**RE: MOOLARBEN OC3 EXTENSION PROJECT – INDEPENDENT EXPERT ADVISORY PANEL FOR MINING
PRELIMINARY REQUEST FOR ADDITIONAL INFORMATION**

**MOOLARBEN OC3 EXTENSION PROJECT – INDEPENDENT EXPERT ADVISORY PANEL FOR MINING PRELIMINARY
REQUEST FOR ADDITIONAL INFORMATION RECONCILIATION TABLE**

RE: Moolarben OC3 Extension Project - Independent Expert Advisory Panel for Mining - Groundwater Responses

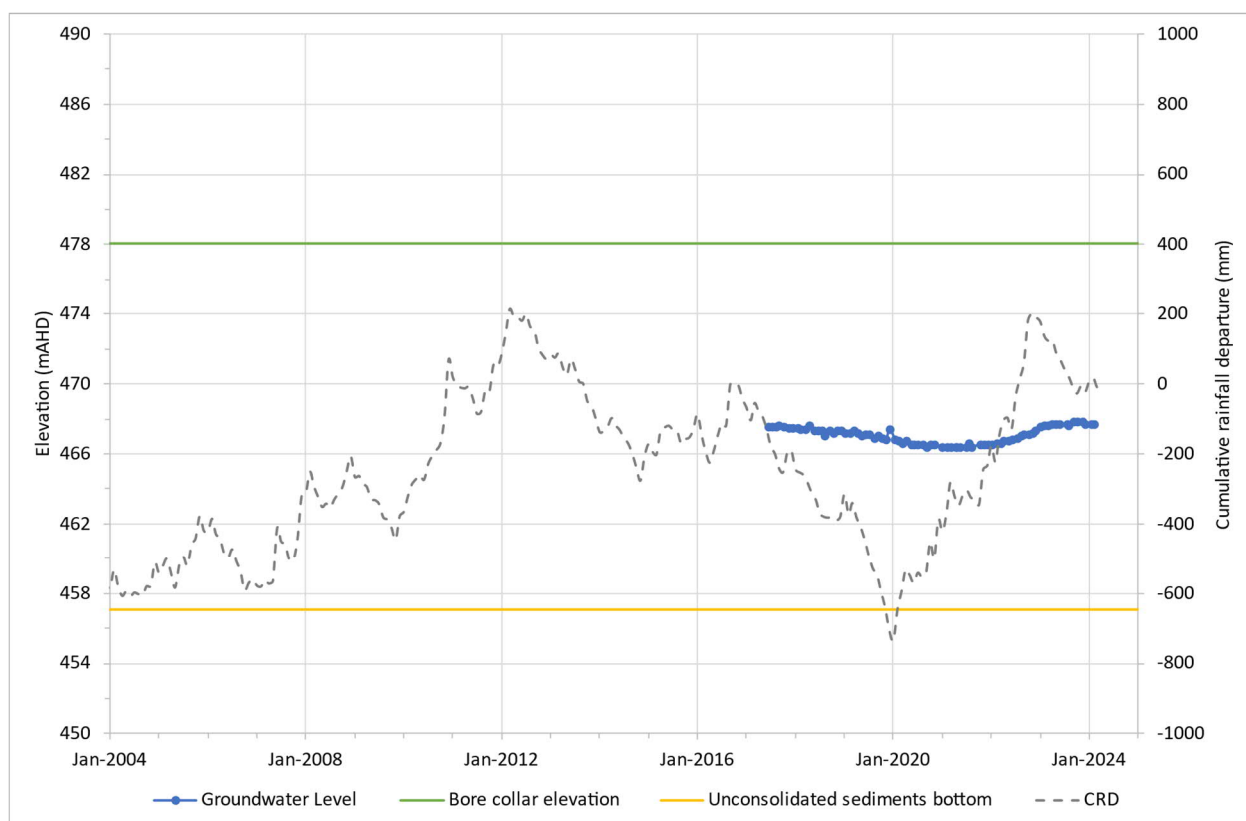
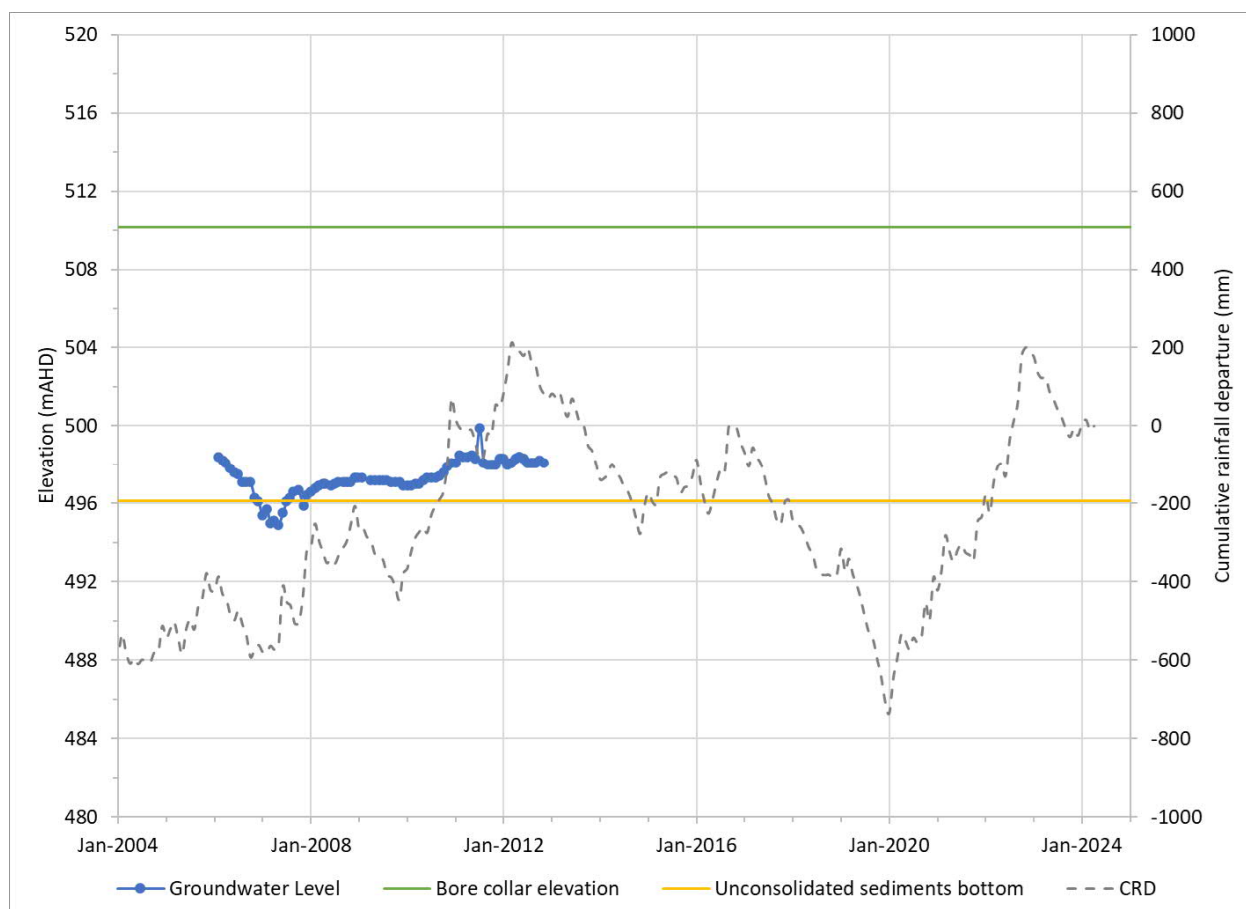
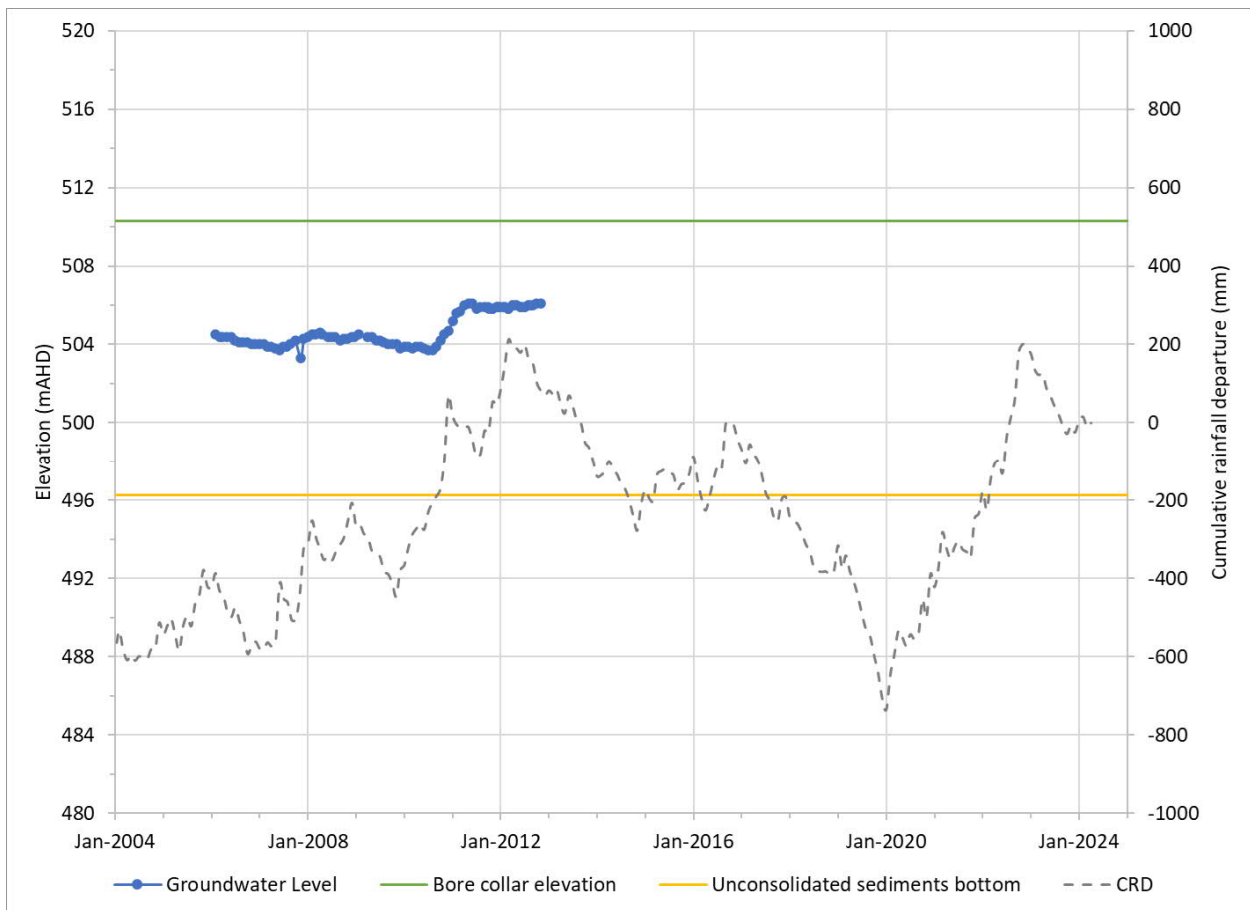
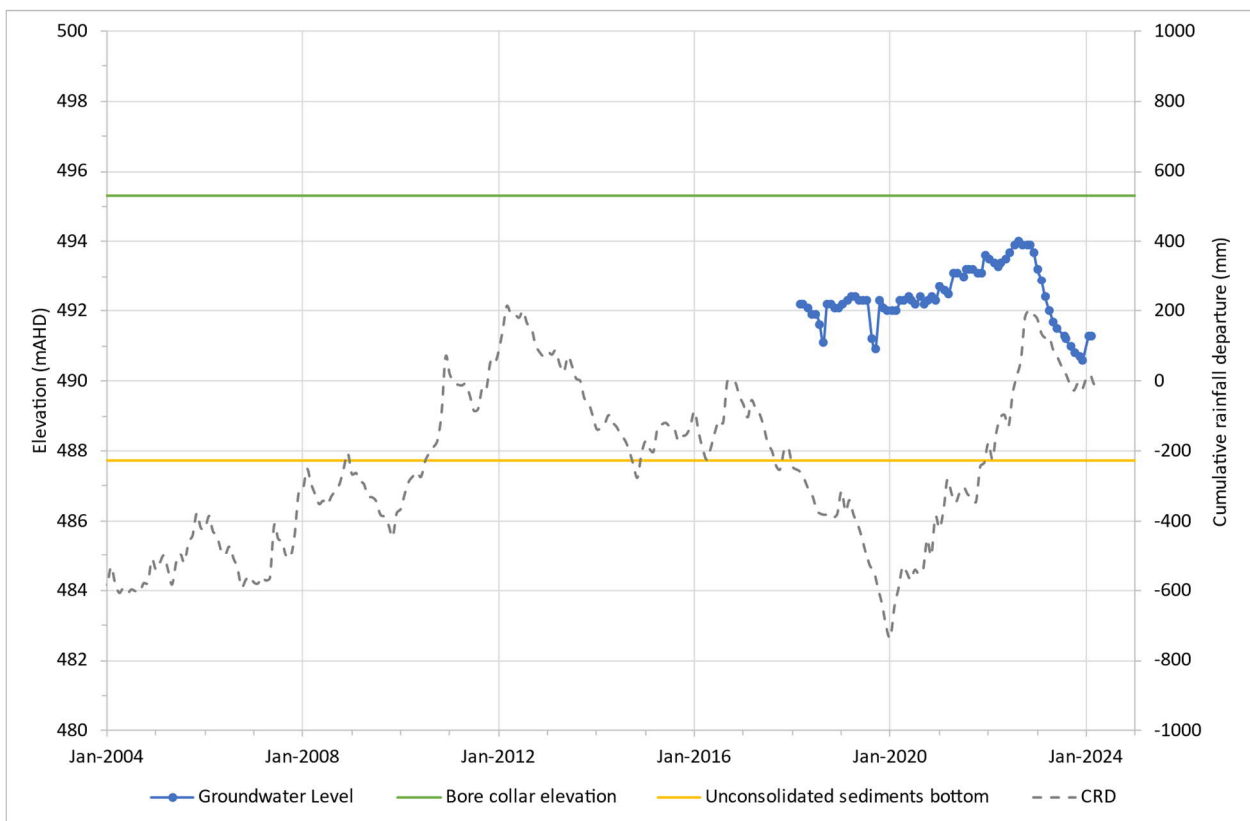
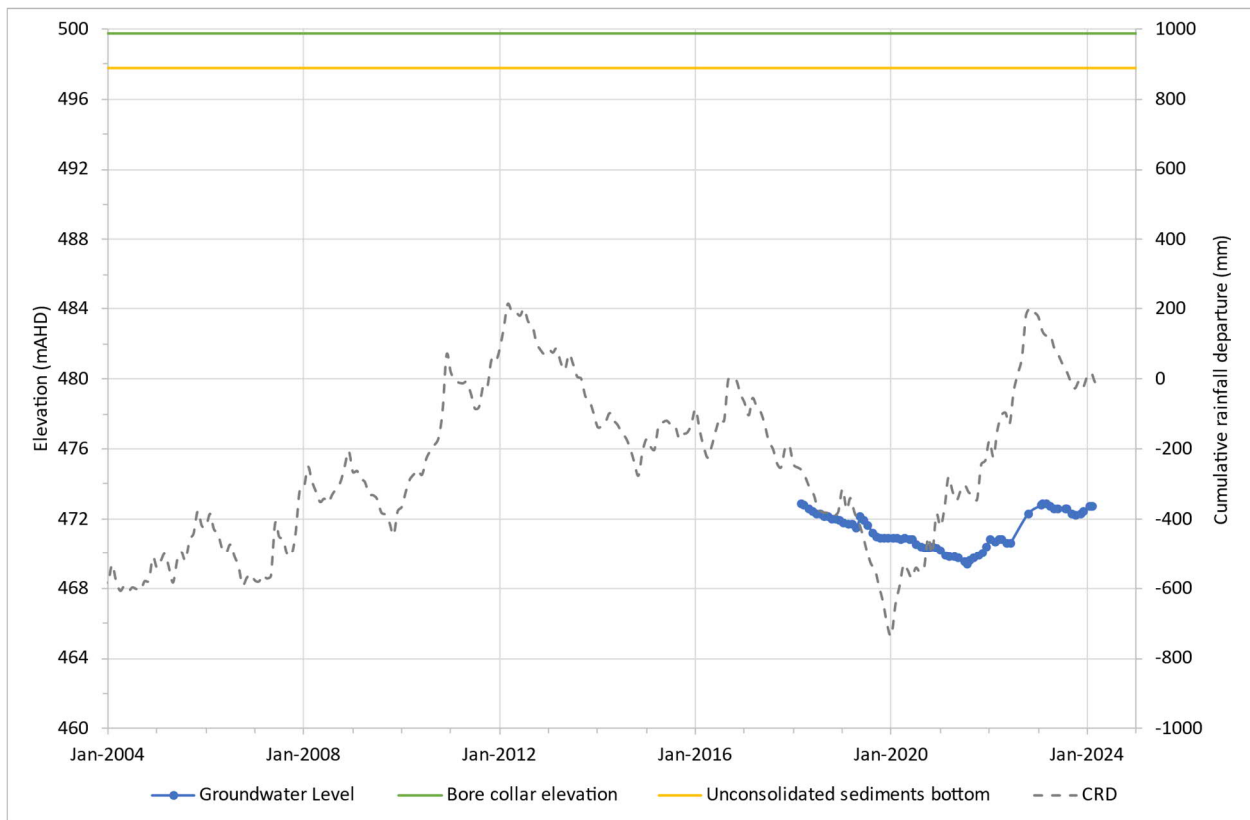
- *Can the Panel please have access to the monitoring data to support the claim that “large areas of the project are currently unsaturated, limiting the potential for impacts associated with changes in groundwater levels”?*

Figure 2-2 to Figure 2-8 show the recorded groundwater levels at each monitoring bore, along with the following information:

The charts show consistently unsaturated conditions within the unconsolidated deposits at monitoring sites PZ044 and PZ221. At monitoring site PZ003 the unconsolidated sediments were saturated for a short period of time in late 2022/early 2023 (coincident with extended wet periods). Monitoring sites PZ058A, PZ072A, PZ072C and PZ217 show permanent (or almost permanent at P072A) saturated conditions within the unconsolidated sediments, noting that P072A and PZ217 are screened within the Ulan Seam formation.

ATTACHMENT 6 – SURFACE WATER MONITORING SITES

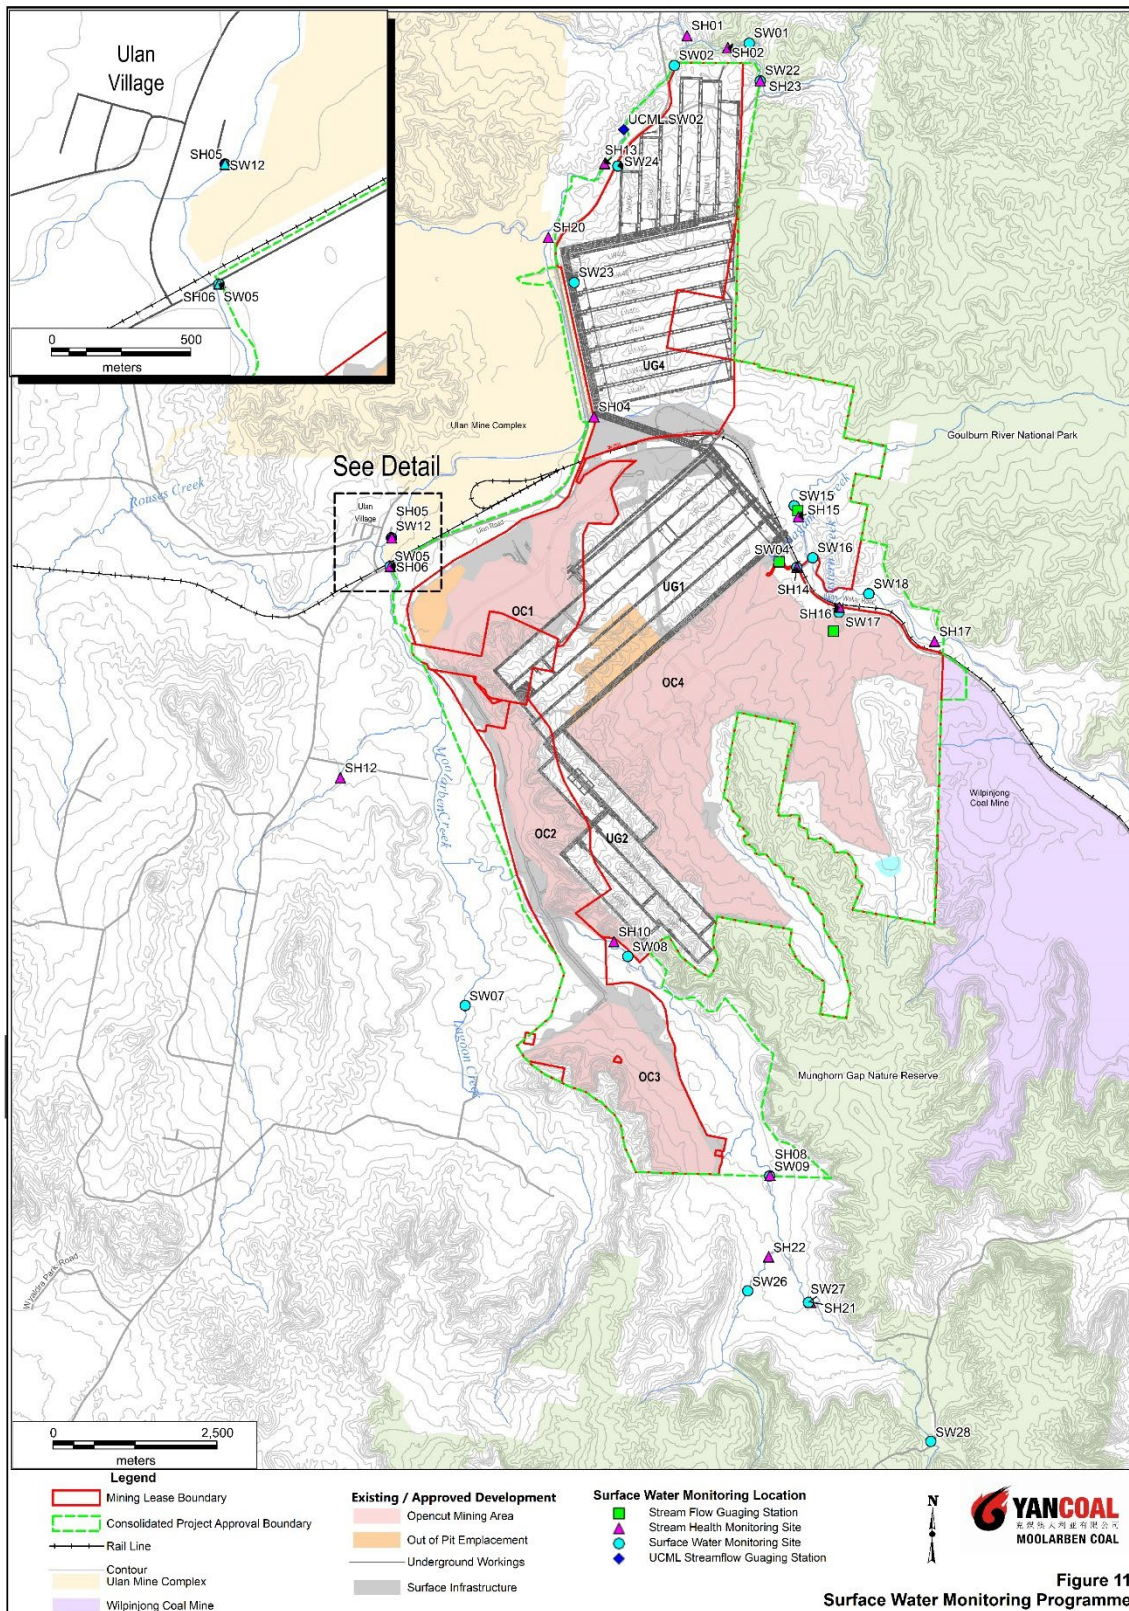
Information Required	Response
<i>Has the proposed SW WQ site on Murdering Creek been established?</i>	Yes, Attachment 6 provides a figure which depicts the new locations of the surface water monitoring sites (SW26, SW27, SW28).
<i>Are additional SW monitoring sites being proposed along Moolarben Creek as per the IESC advice?</i>	Yes, as stated in the Submissions Report MCO accepts the IESC recommendations regarding the establishment of additional water quality monitoring locations.
<i>It is noted that one of the few available gauging stations that has been referred to (SW01) has incomplete data “due to difficulties in ascertaining a robust curve due to the presence of reeds and periods of no flow”. The Panel would like to know whether efforts have been made more recently to improve the monitoring at this site (SW01)?</i>	- It should be noted there is significant uncertainty associated with collecting accurate flow data in these ephemeral creeks with sandy stream beds, due to inherently changing streambed dimensions, affecting streambed cross section accuracy at the gauging station location (i.e. it is not possible to construct v-notch weirs along the Goulburn River). - In addition, SW01 is located downstream of Moolarben Dam and gauged flows have limited relevance to the Project (as the upstream flows from the Moolarben Creek catchment are controlled by releases from Moolarben Dam). This gauging station is not operated by MCO, and is operated by Ulan Coal. - MCO has installed additional flow gauges downstream of the SW01 on the Goulburn River.

Figure 10

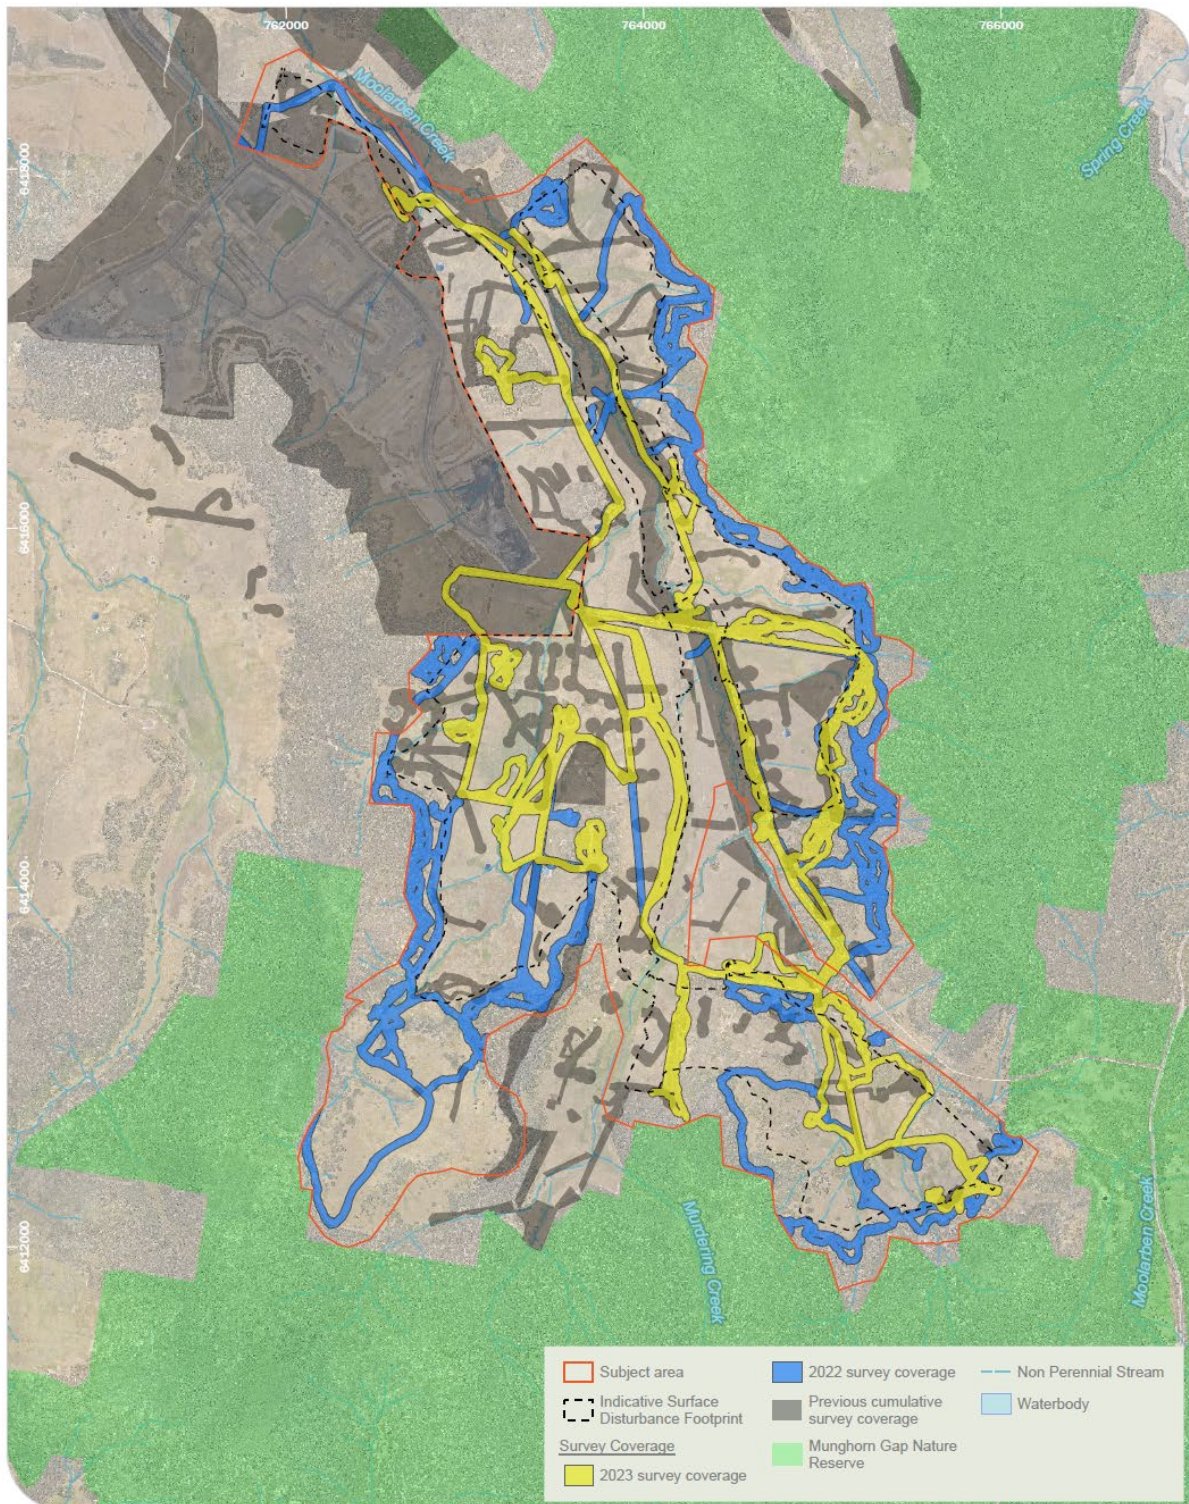
Aboriginal heritage	
<i>Heritage NSW have pointed out that there are many cultural heritage sites associated with Moolarben Creek and that it is unclear if this area has been extensively surveyed. Is further information available on the cultural heritage surveys that have been carried out at Moolarben Creek?</i>	- There has been extensive survey of Moolarben Creek to date, both associated with the Project Aboriginal Cultural Heritage Assessment and in previous assessments. - It is noted that avoidance of open cut mining within 200 m of Moolarben Creek was proposed in the EIS and is also proposed for the amended Project. In addition, extensive avoidance of other disturbance along Moolarben Creek is proposed for the Project. - Figure 10 from the ACHA for the Amended Project, which shows survey coverage, is provided in Attachment 7 to this response.
